Access Compliance Report

Public Rights-of-Way

(Curb Ramps)

Intersection ID: 25705	Main Street: REA_RD	Cross Street: SUNDANCER_LN	Location: NW
ADA ID: 42349410C22C	Ramp Type: Directional1	Initial Pass/Fail: Fail	Overall Compliance: No
Severity Score: 1.25			
Codes/Mitigation Info/Possible Solution		Field Measurements/Component Compliance

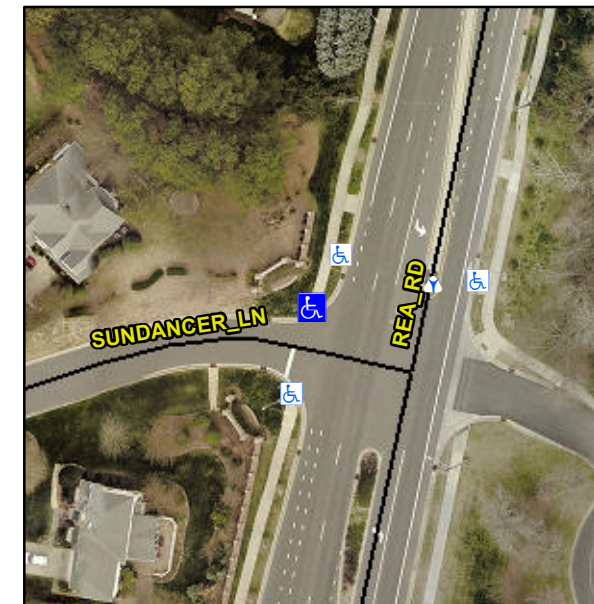
R304.5.3

Compliance	Description	Data	Compliance	Description	Data
N/A	Ramp Length (in)	84.0	N/A	Grade Break?	N/A
Yes	Ramp Width (in)	70.0	N/A	Grade Break Slope (%)	0.0
Yes	Ramp Slope (%)	0.7	N/A	Grade Break XSlope (%)	0.0
No	Ramp XSlope (%)	3.8			
N/A	Flare Type LT	N/A	N/A	Flare Type RT	N/A
N/A	Flare Slope LT (%)	N/A	N/A	Flare Slope RT (%)	0.0
N/A	Flare Traversable LT?	N/A	N/A	Flare Traversable RT?	N/A
N/A	Landing Length (in)	0.0	N/A	DWS Provided?	N/A
N/A	Landing Width (in)	0.0	N/A	DWS Contrast?	N/A
N/A	Landing Slope (%)	0.0	N/A	DWS Length (in)	N/A
N/A	Landing X Slope (%)	0.0	N/A	DWS Full Width?	N/A
N/A	Landing Curb? (Y/N)	N/A	N/A	DWS Offset LT (in)	N/A
N/A	Shared Landing?	N/A	N/A	DWS Offset RT (in)	N/A
N/A	Gutter Ponding?	0.0	N/A	Gutter Slope (%)	N/A
N/A	Gutter Lip Ht (in)	0.0	N/A	Gutter X Slope (%)	N/A
N/A	Painted X Walk1?	No		Road Slope (%)	3.7
	X Walk 1 Direction	To S		Road X Slope (%)	1.4
	X Walk 1 Width (in)	N/A		Clear Space?	N/A

Remove & Replace Entire Ramp.
